SERVICE BULLETIN

Bulletin Part Number: 296133-B1

Product: L1 Model II and L1 Model 1S Power Stands

Subject: Power supply failure.

Figure 1. C16 and C24

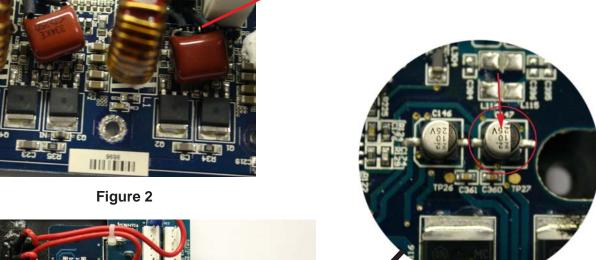
Solution: Using the part numbers referenced in the table below, replace C16 and C24 on both power amplifier PCBs. See figure 1 on the next page. When replacing the C16 and C24 make sure you add heat shrink tubing to the wire leads of the capacitor. See figure 2 on the next page. The caps should also be spaced 1mm away from the inductors and add adhesive (RTV) to keep them in place. **NOTE:** The adhesive can cover the components, but keep the adhesive away from the large inductors (L1 and L3). Replace C147 and remove C264 on the DSP PCB. See figure 3 on the next page. Replace both fans. Update the software to enable improved performance in the idle state. The software is posted to the L1 Model II and L1 Model 1S systems repair information page.

Shrink tubing on leads.

Figure 3. C147

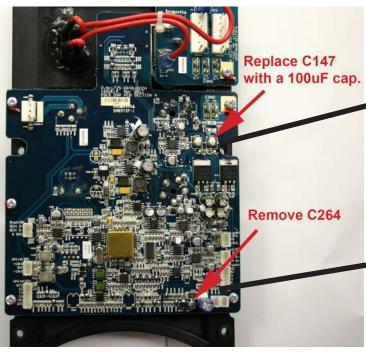
Part Number	Description	Reference Designator	PCB
731972-001S	0.33uF, PP, 250V, 5%	C16, 24	Power Supply
731975-001S	100uF, EL, 0607, 25V, 20%	C147	DSP
Remove part	Remove part	C264	DSP
731974-001S	FAN, 12 VDC, 5400, 40X40, DUAL BALL	FAN	-
